CHANGE ORDER

No. 1

PROJECT: Lincoln Park Water Line Replacement Project PWP-DO-2003-108

Attachments: **Exhibit A, Exhibit B and revised Sheets C3, C4 and D1.**

DRAWING: C3
SHEET: 6 OF 12
REVISION NUMBER:
DATE:

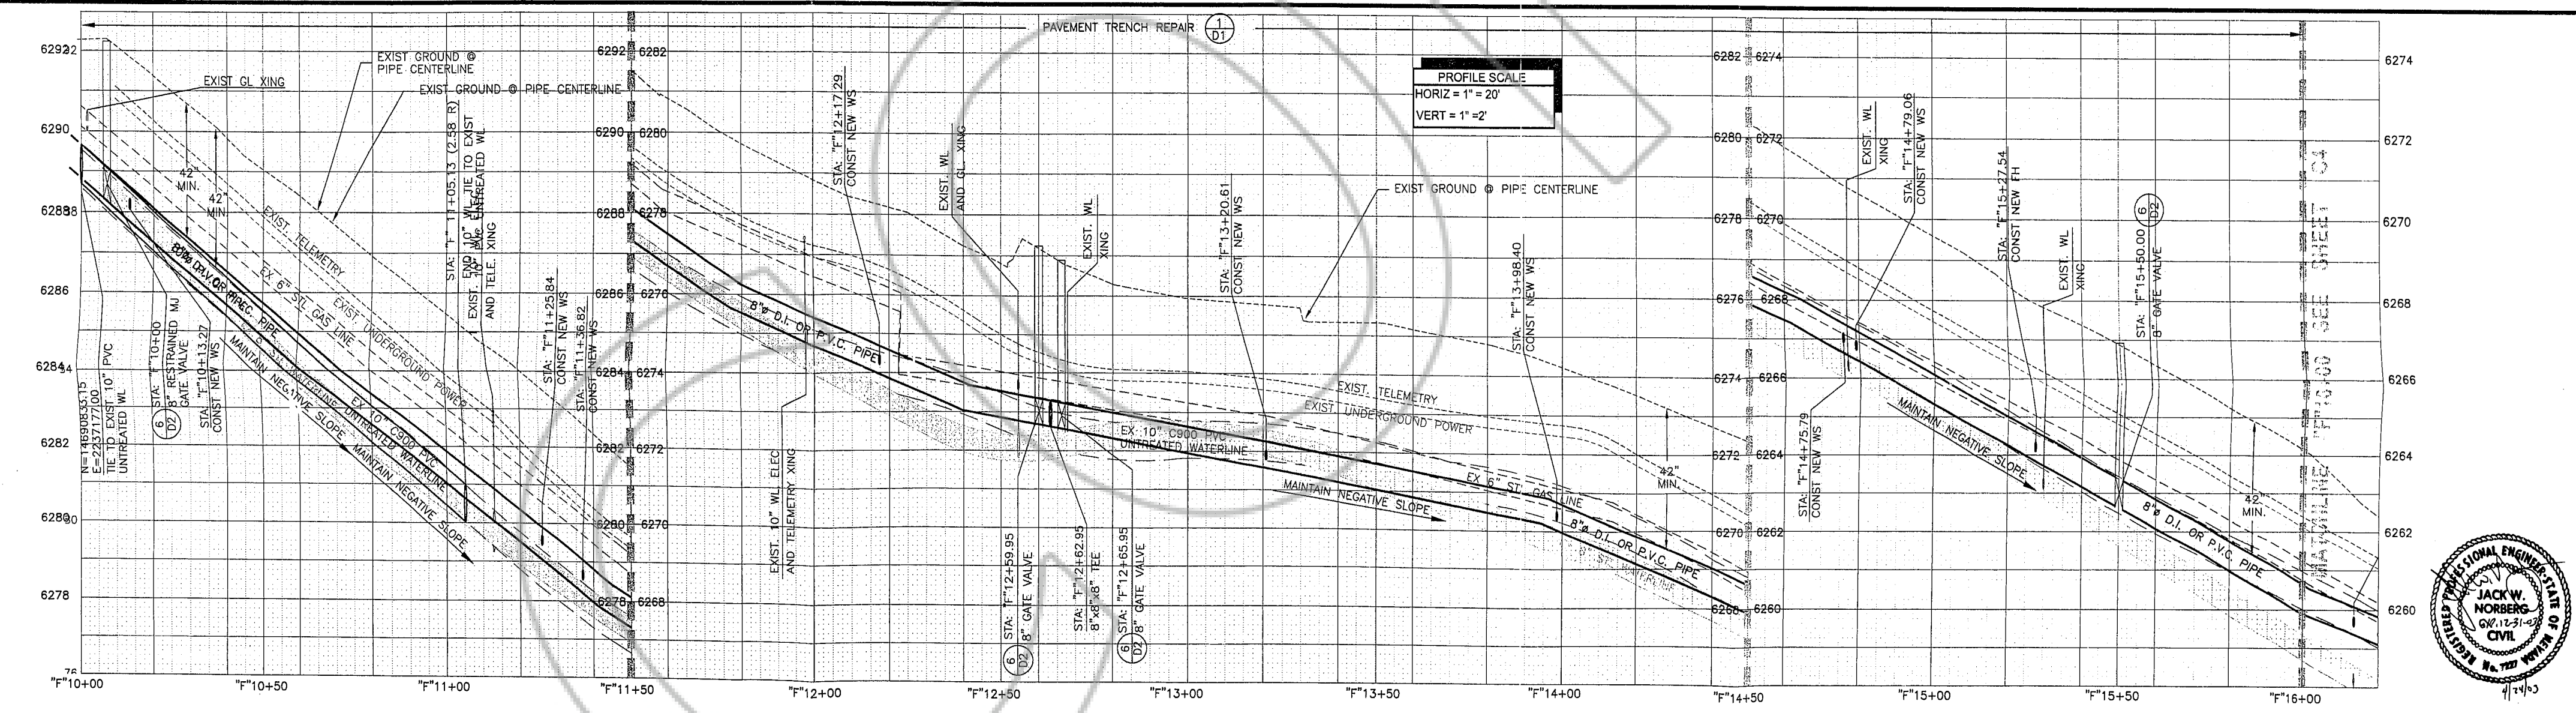
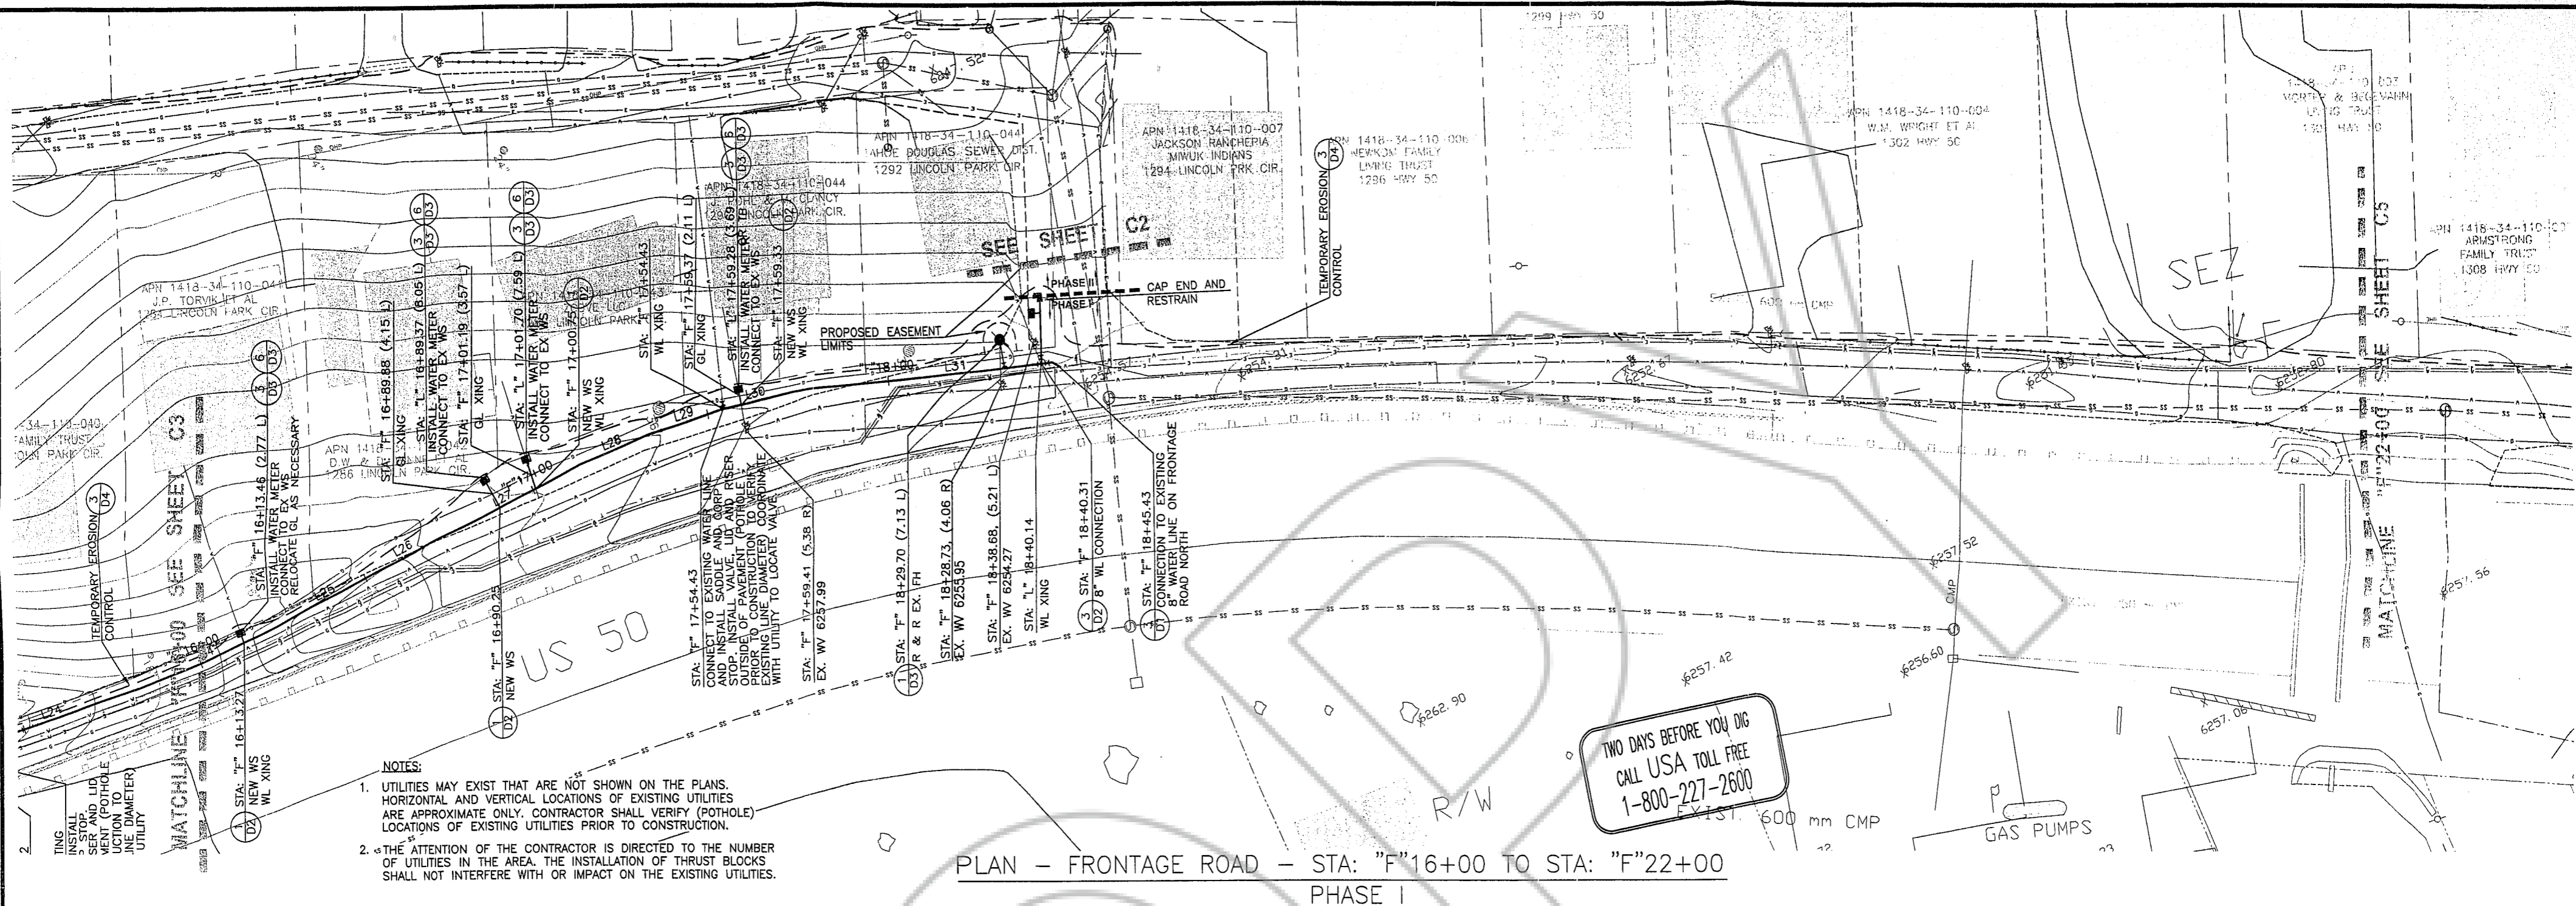
- a. **Delete 8-Inch Ductile Iron Restrained Joint Pipe:** Delete water line from approximately Station "F" 18+45 to "F" 23+78 and relocate connection to existing water main to approximately Station "F" 00+00 per the attached drawing. Estimated bid quantity for Bid Item A-3 of 392 LF was not correct. Net reduction in pipeline quantity is 369 linear feet. Revised estimated quantity is 23 linear feet.

- b. **Delete fire hydrant assembly at Station "F" 21+69.92.**
- c. **Delete 3 Water Service Connections:** Delete water service locations at Stations "F" 19+98.67, 20+42.21, and 21+16.93. Original estimated quantity of 12 was not correct. Original quantity should have been 15. Therefore amended quantity is 12 and requires no adjustment in contract quantity.

DRAWING: C4
SHEET: 7 OF 12
REVISION NUMBER:
DATE:

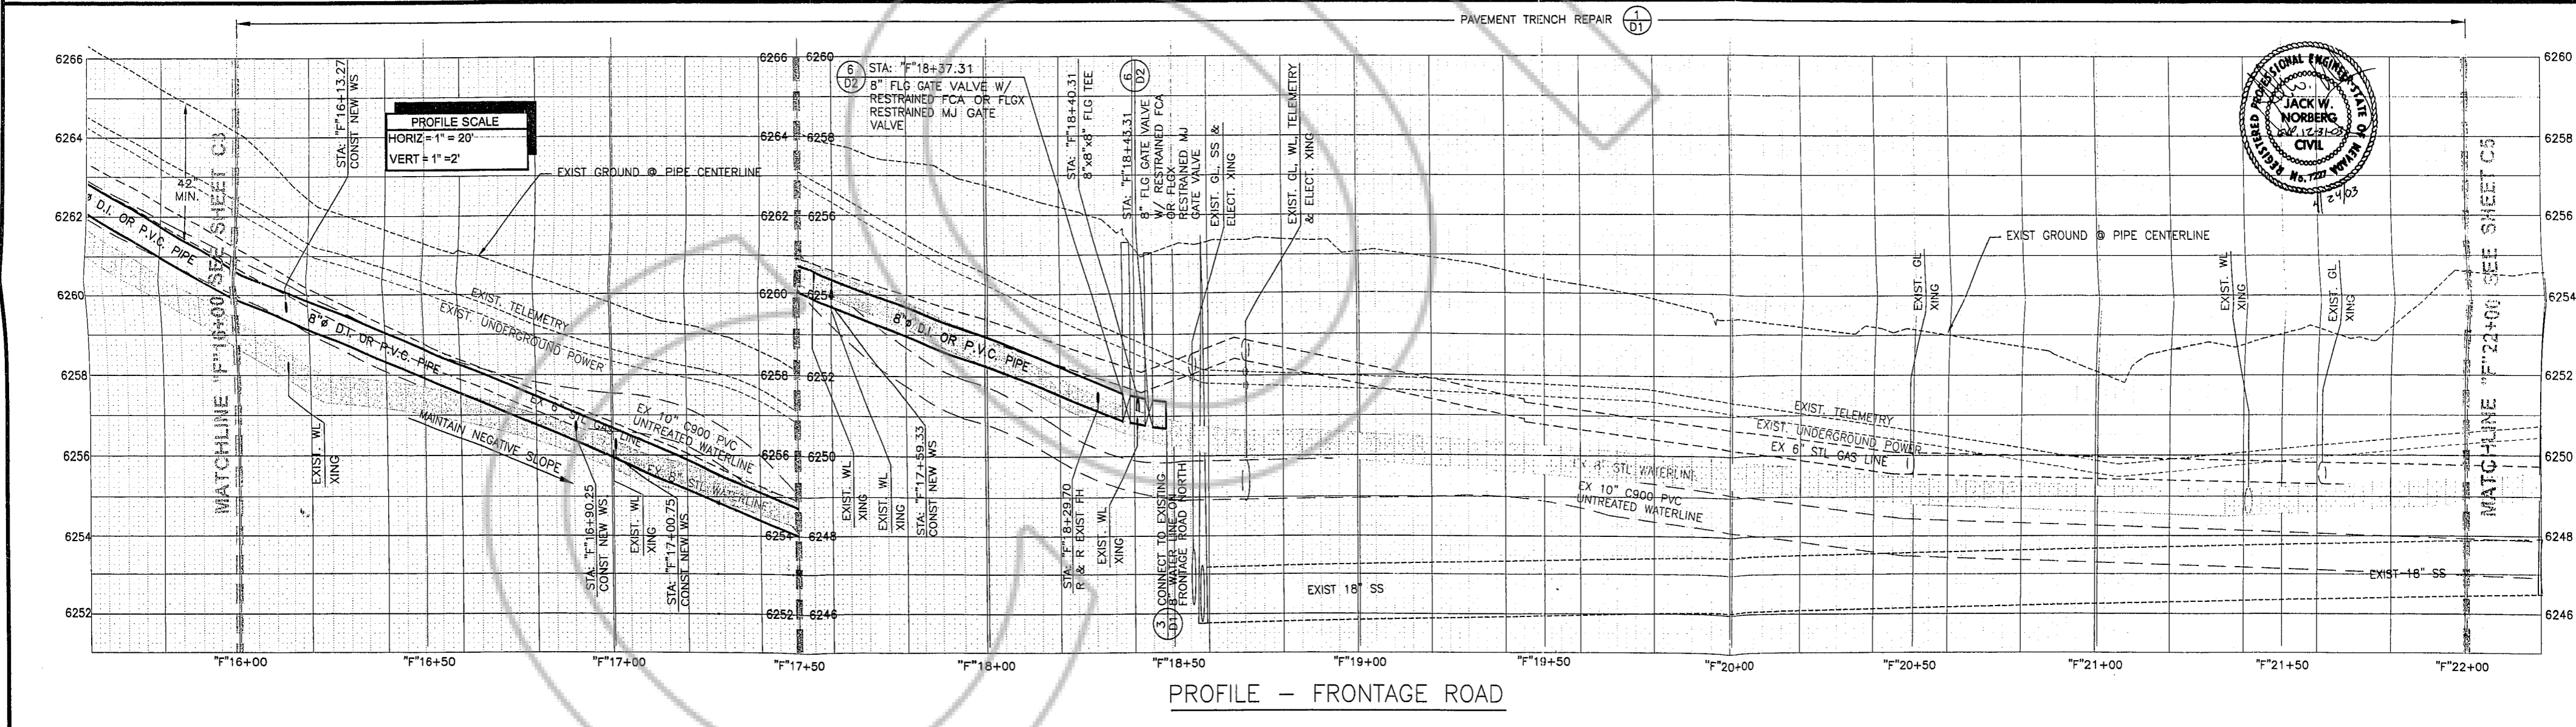
- l. **Amend Unit Cost for Bid Item A-15 Construction Staking:** Change unit cost for Bid Item A-15 Construction Staking from \$3,500 to \$3,300 lump sum. Reduction in contract price is \$200.
- m. **Delete the Combination Air Valve at Station "F" 23 + 50.**
- n. **Install North Connection to Existing Water Line:** Install connection at approximately Station "F" 18 + 45.43 per the revised Sheets C4 and D1.
- o. **Reconnect Water Laterals at Stations "F" 15 + 29 and "F" 17 + 54:** Cost is \$950 per each lateral reconnected.

- m. **Delete the Combination Air Valve at Station "F" 23+50:** Reduction in contract price is \$2,250.
- n. **Install North Connection to Existing Water Line:** Connection point changed to station "F" 18+45 because water line was deleted from Station "F" 18+45 to "F" 23+78.
